Appendix E
Transportation Memo

Memorandum

Subject: Transportation Analysis for the Proposed Commercial Development at 696 Blossom Hill Road in San Jose, CA

Figure 2
Site Plan

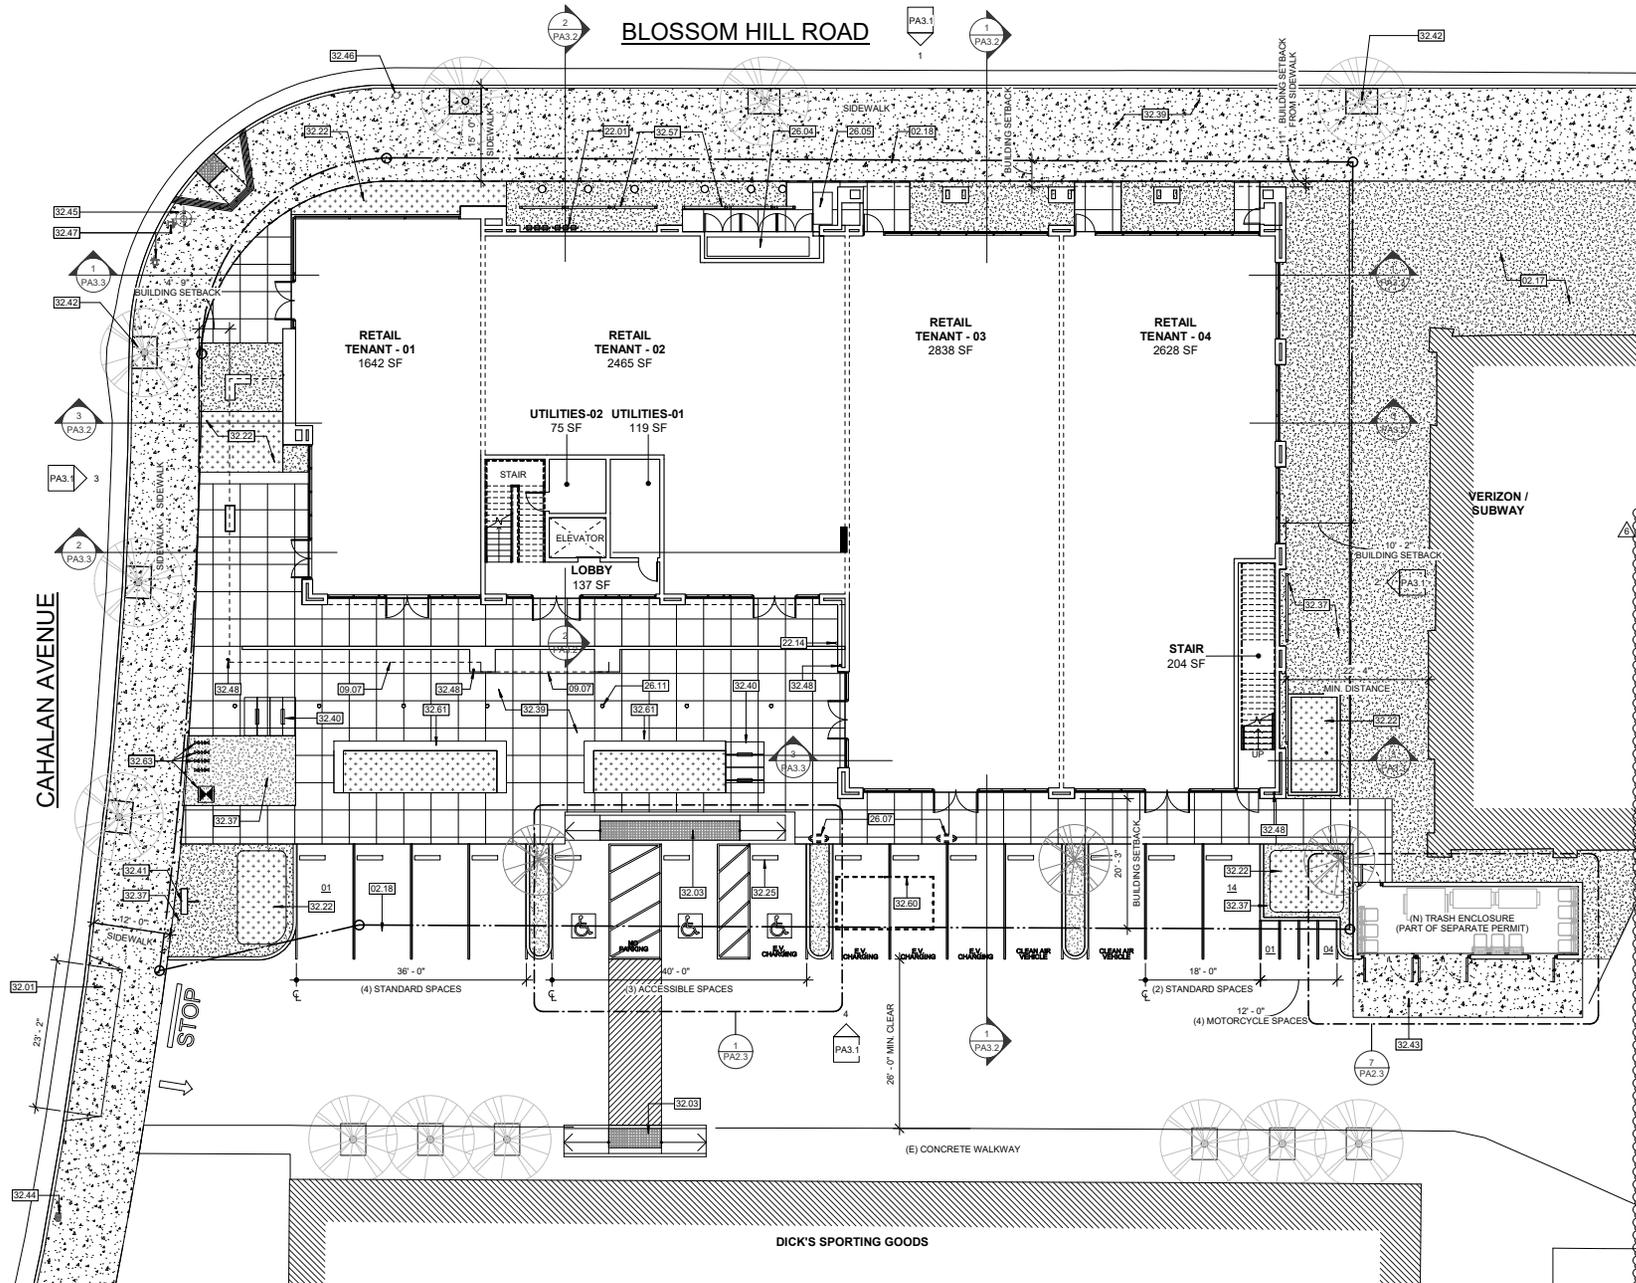
Vehicular access to the project site would be provided via an existing full access driveway on Cahalan Avenue. The City of San Jose standard driveway width for commercial developments is 26 feet wide. The standard width provides adequate width for vehicular ingress and egress and provides a reasonably short crossing distance for pedestrians. The driveway is shown to be 23 feet wide.

The Americans with Disabilities Act (ADA) standard for parking stall dimensions is 8 feet wide, or 11 feet wide for van-accessible spaces, with 5-foot-wide access aisles. Van-accessible spaces may be 8 feet wide if adjacent access aisles are also 8 feet wide. The site plan shows all handicap parking stalls to be 9 feet wide and 18 feet long, with access aisles that are 8 feet wide and 4 feet, 11 inches wide.

The site plan does not indicate passenger loading zones along the project frontages or within the parking area for people accessing the site using Uber/Lyft or other rideshare apps (e.g., Scoop, Waze Carpool). Since there are bike lanes along the project frontages on Cahalan Avenue and Blossom Hill Road, passenger loading spaces cannot be located along the curb. Therefore, it is assumed that rideshare vehicles would turn into the project site and passengers would be dropped off within the parking area.

According to the City of San Jose Zoning Code Section 20.90.410, developments having a floor area of 10,000 square feet or more should provide at a minimum one off-street loading space, plus one additional loading space for each 20,000 square feet of floor area. The site plan does not show any loading spaces for the project. However, the Planning Director may approve a development with no off-street loading spaces if the Director finds that the project includes adequate provision for loading taking into consideration the nature of the allowed uses, the configuration of buildings and their relationship to the street.

The project proposes to provide four motorcycle parking spaces, which would meet the City's motorcycle parking requirement. The project proposes to provide eight bicycle parking spaces, which would meet the City's bicycle parking requirement. The site plan does not show any long-term bicycle parking facilities.

Recommendation: Prior to final design, the driveway should be shown to have a width of 26 feet.

Recommendation: Prior to final design, the project applicant should ensure that all accessible parking spaces meet the ADA requirements.

Recommendation: The project applicant should coordinate with City staff to determine if any loading spaces would be required to serve the project.

Recommendation: The project should consider adding up to two long-term bicycle parking spaces to serve employee needs.
